OREGON TECH

PROJECT CONSISTS OF INTERIOR RENOVATIONS & SITEWORK INTENDED FOR USE AS MENTAL AND BEHAVHIORAL HEALTH CLINIC.

- A. DATE: April 15, 2024
- B. PROJECT: OIT Applied Behavioral Analysis Clinic
- C. PROJECT NUMBER: 23020
- 1.02 TO: PROSPECTIVE BIDDERS:
 - A. This Addendum forms a part of the Contract Documents and modifies the Bidding Documents dated March 22, 2024, with amendments and additions noted below and specifications sections and drawings enclosed or attached.

- PART 2 AMENDMENTS AND ADDITIONS
- 2.01 CLARIFYING QUESTIONS:
 - A. See responses to Bid #2024-02 Clarifying Questions 1.
- 2.02 CHANGES TO THE DRAWINGS:

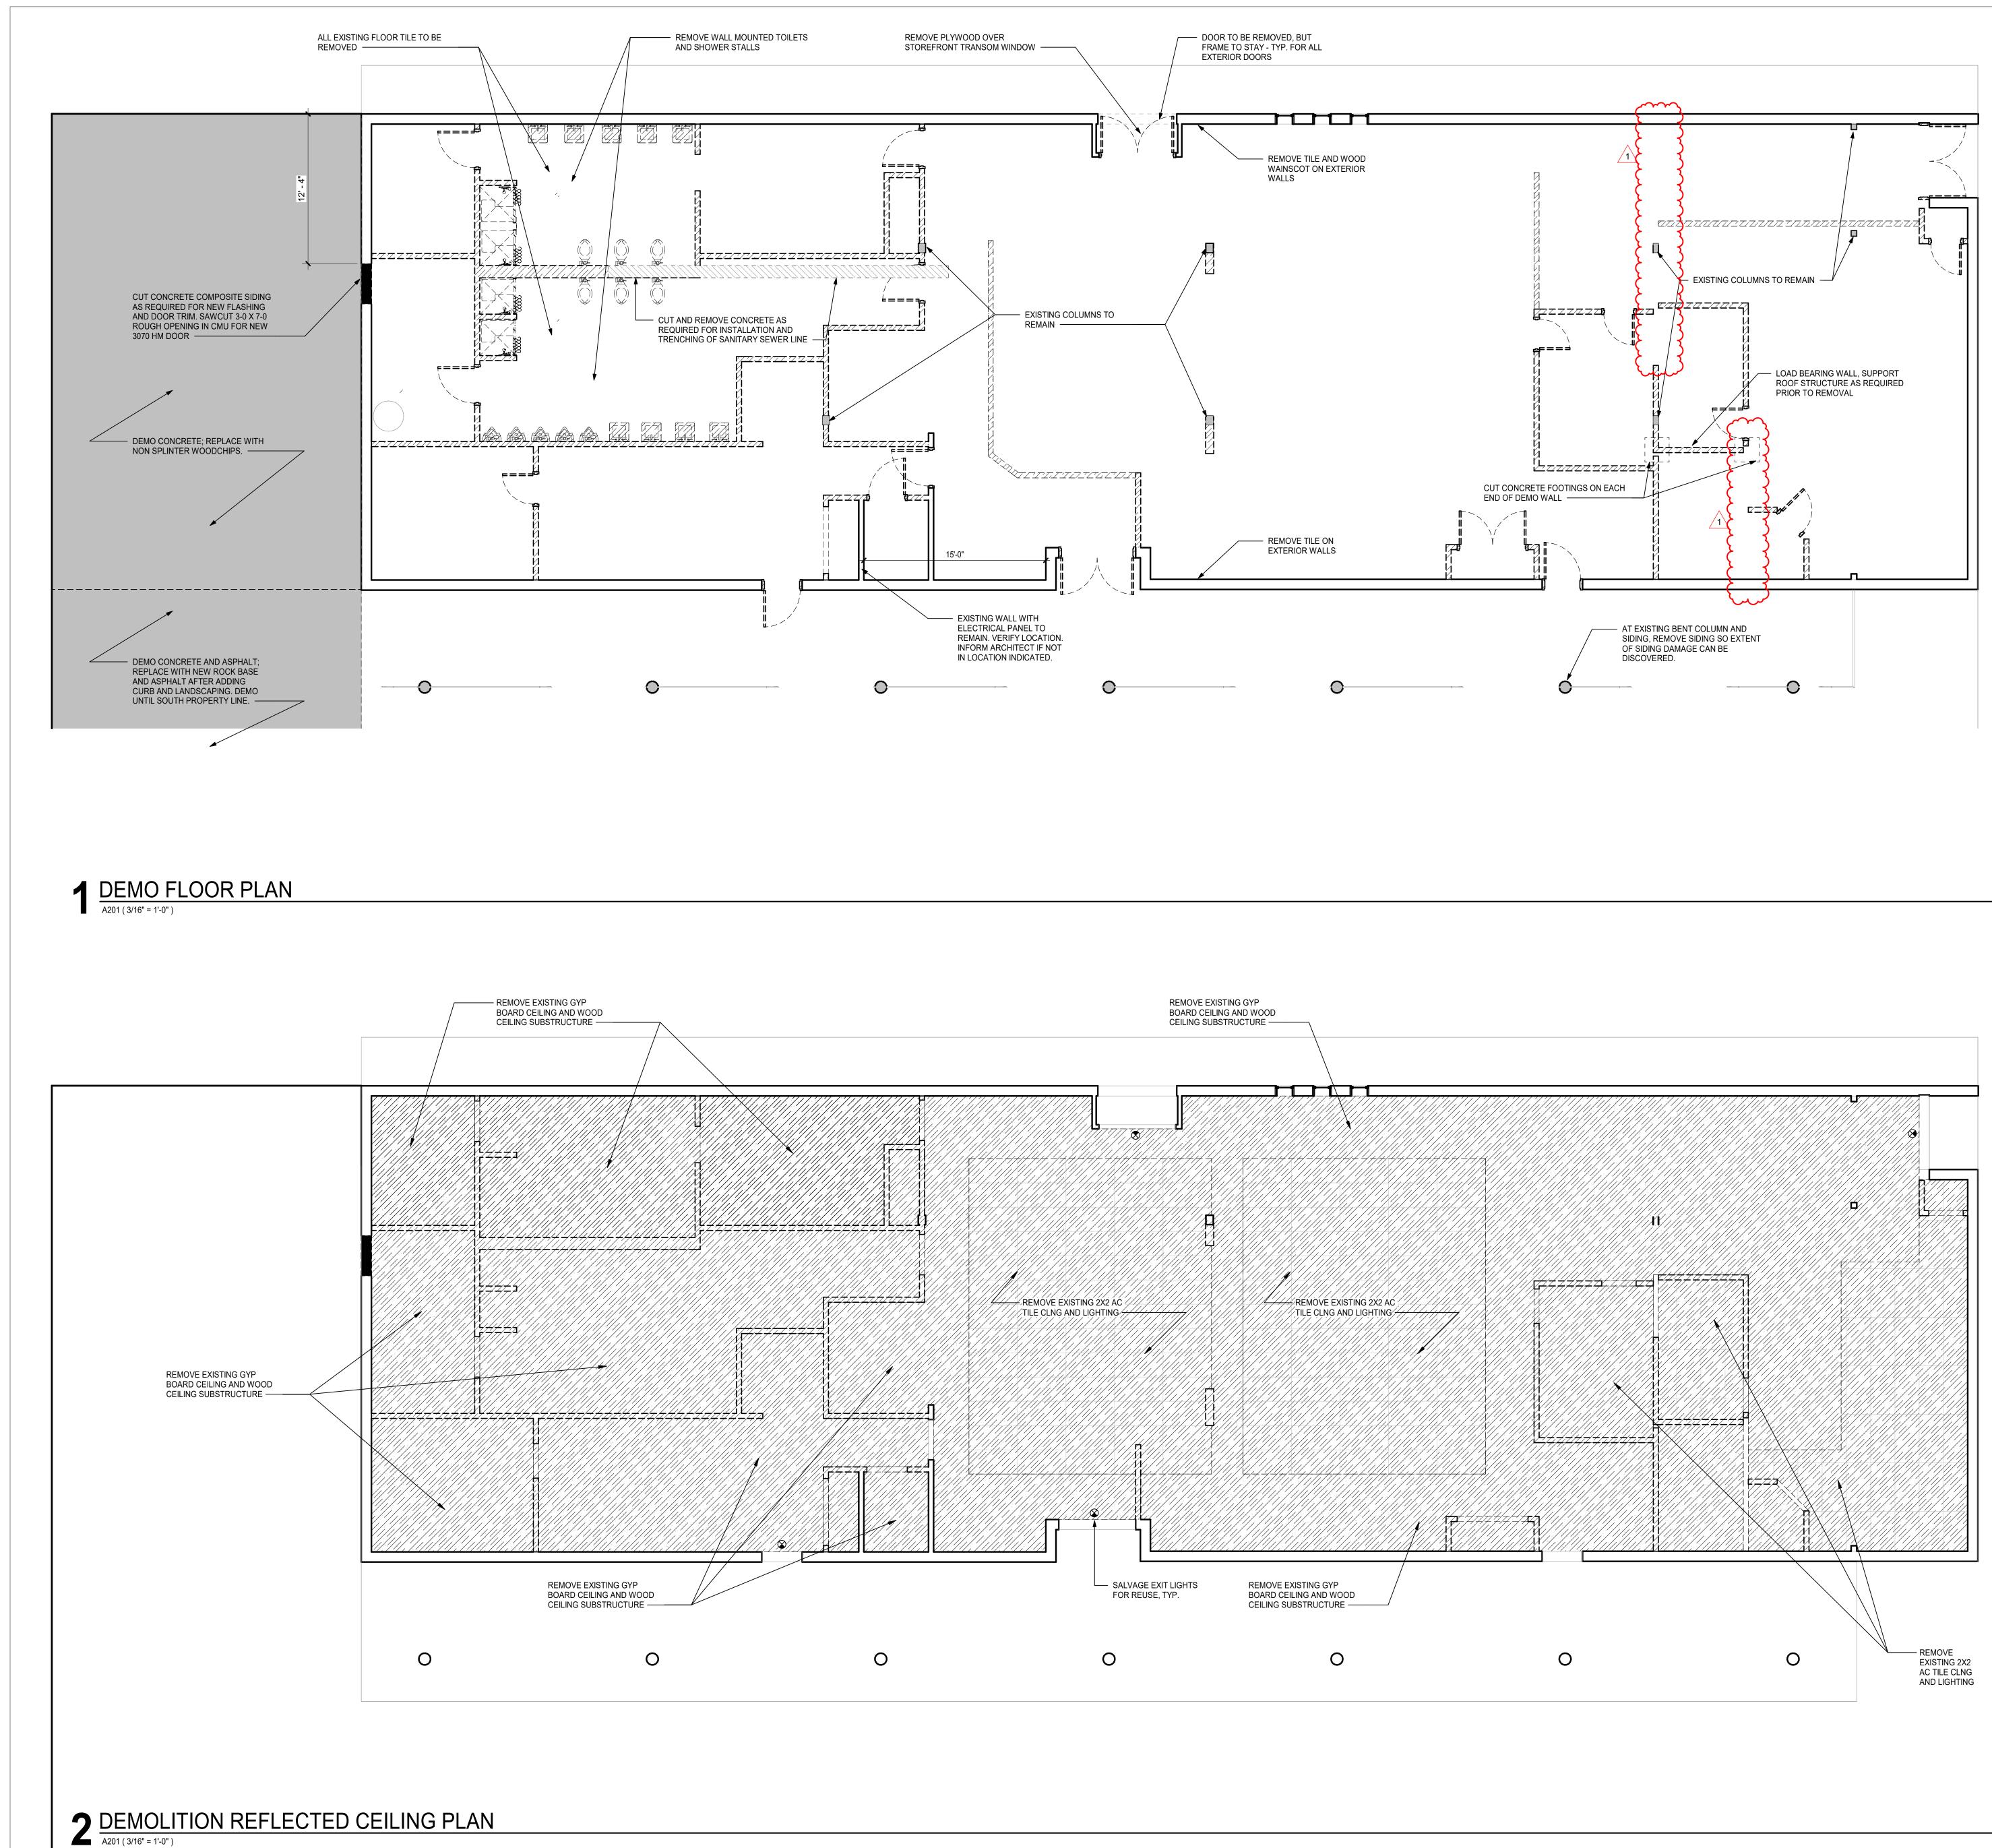
- A. ARCHITECTURAL DRAWINGS
 - 1. Revise Sheets G101, A101, A201, A202, A301, A801 per attached.
 - a. Changes made to floor plan to keep existing structural wall between Offices 114 and 155 and Private Therapy rooms 112 and 113.

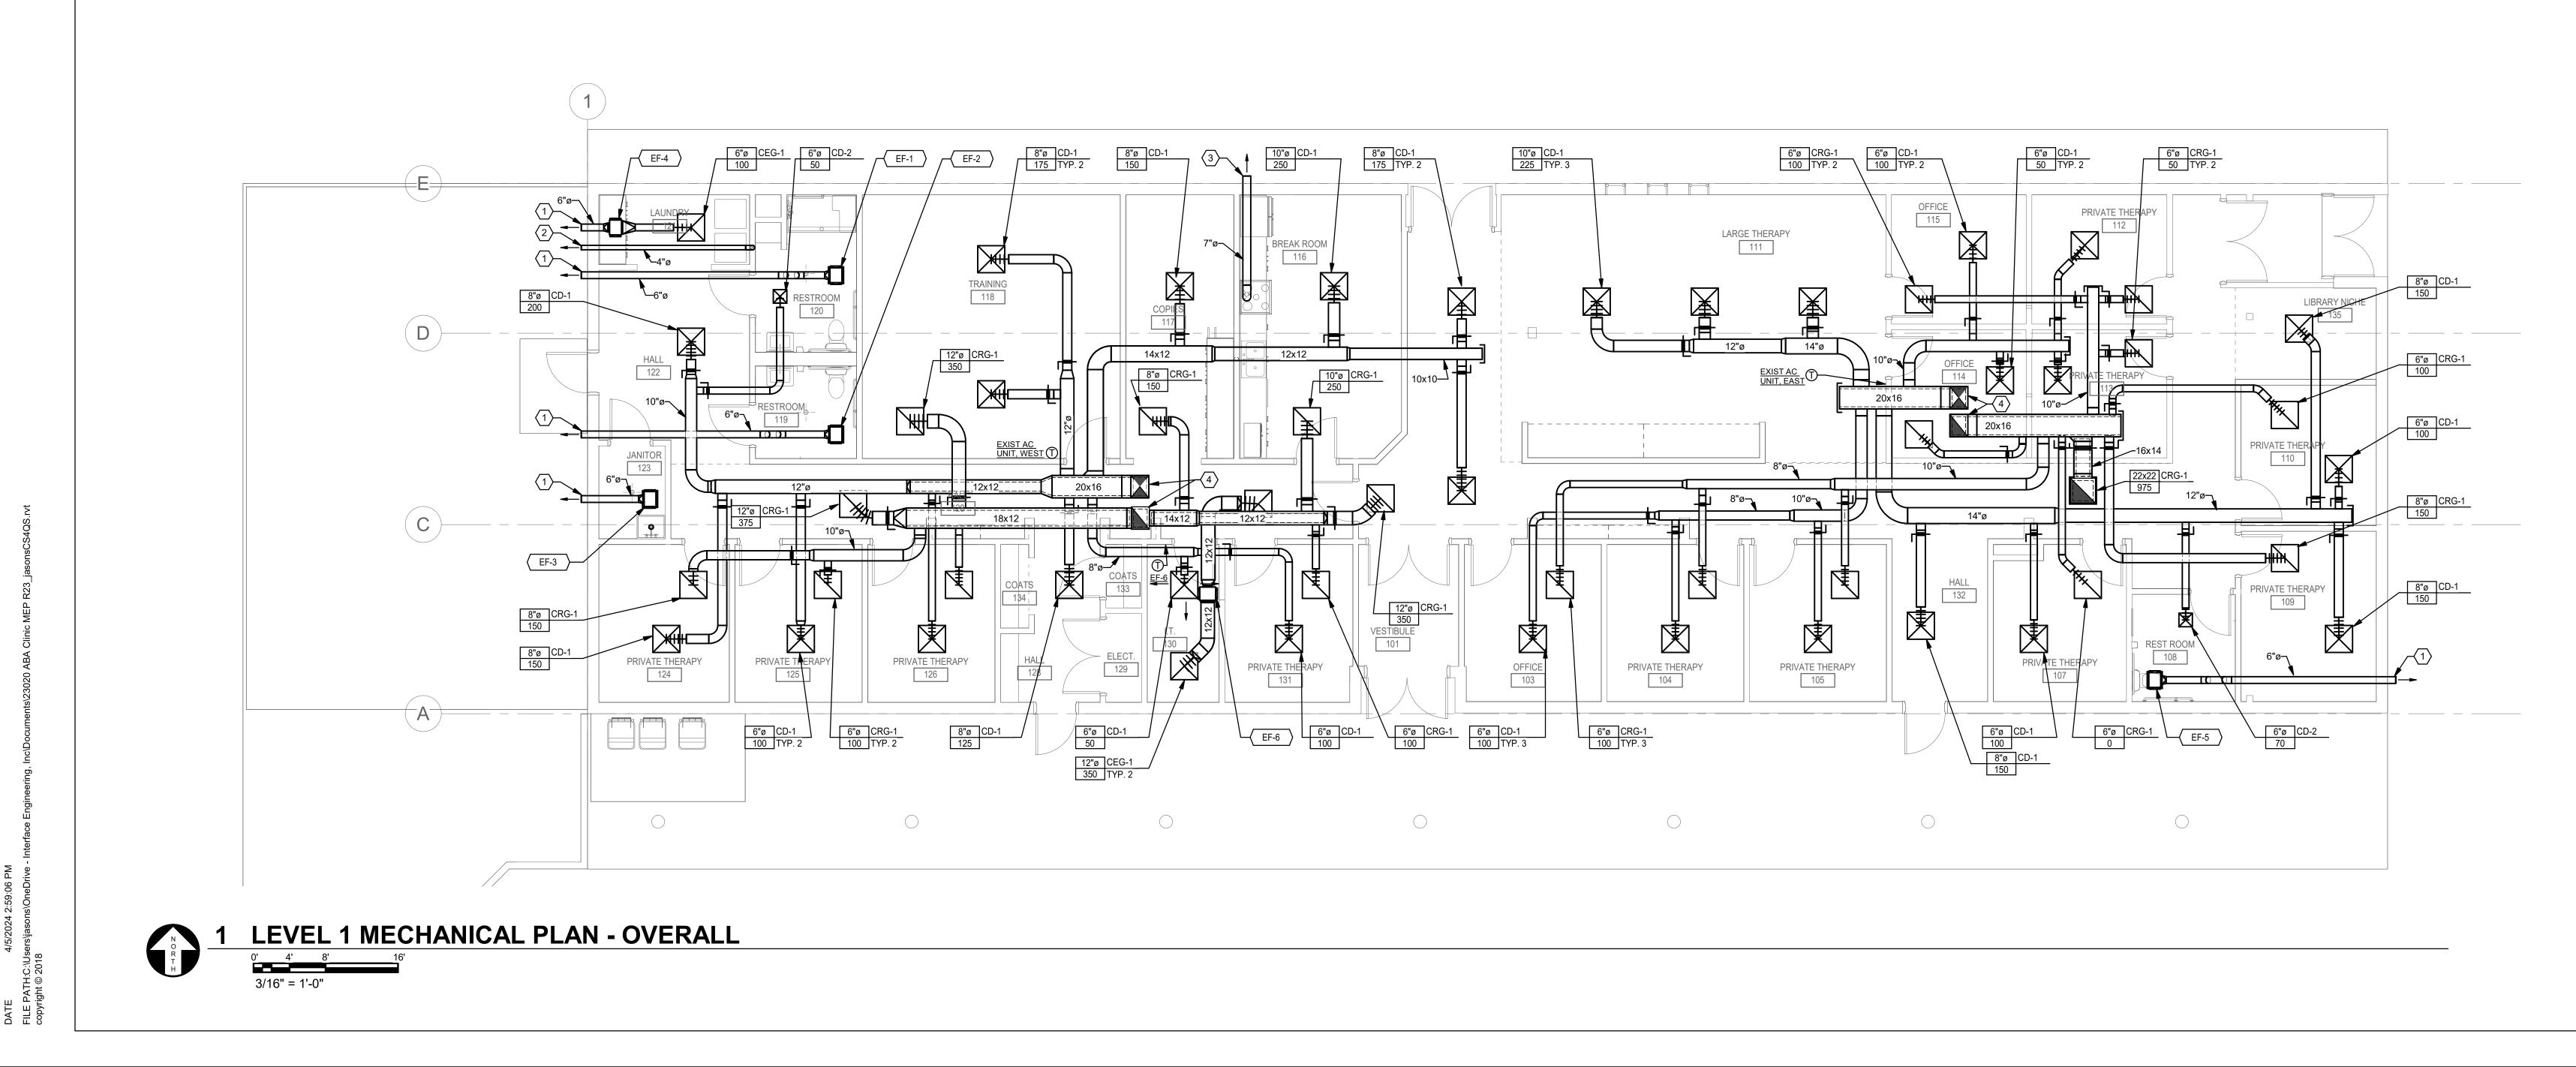
- B. MECHANICAL DRAWINGS
 - 1. Revise Sheets M002, M201 per attached.
 - a. Vents and ducts rerouted to accommodate changes in floor plan to keep existing structural wall.

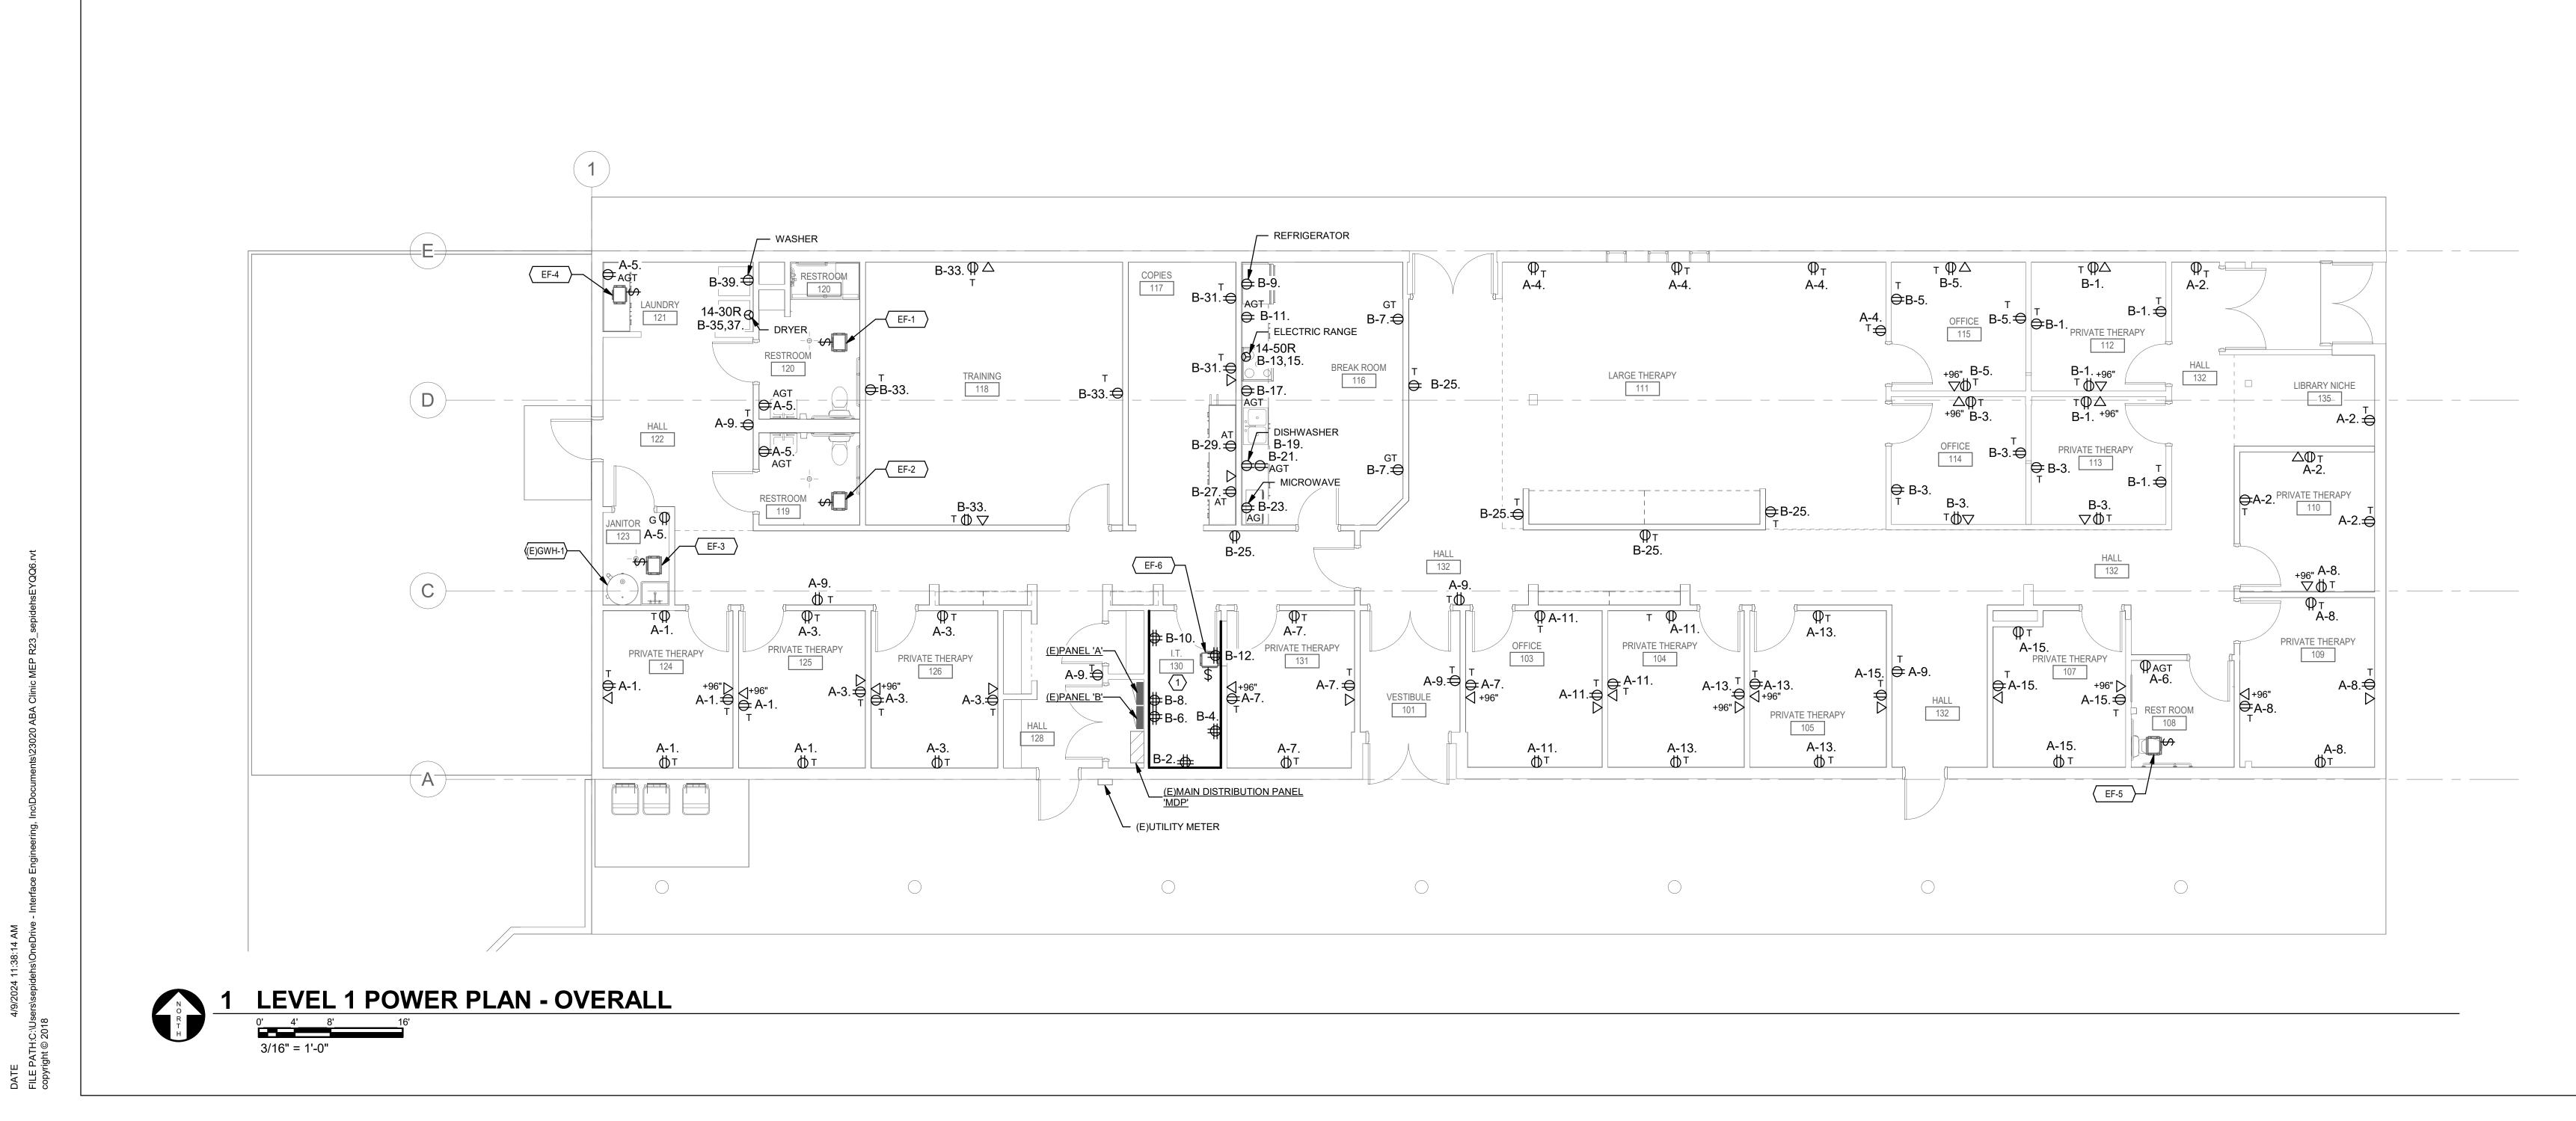
- C. ELECTRICAL DRAWINGS
 - 1. **Revise** Sheets E002, E201, E301, E501 per attached.
 - a. Lighting Plan and Power Plan adjusted to accommodate changes in floor plan. Luminaire Schedule updated.
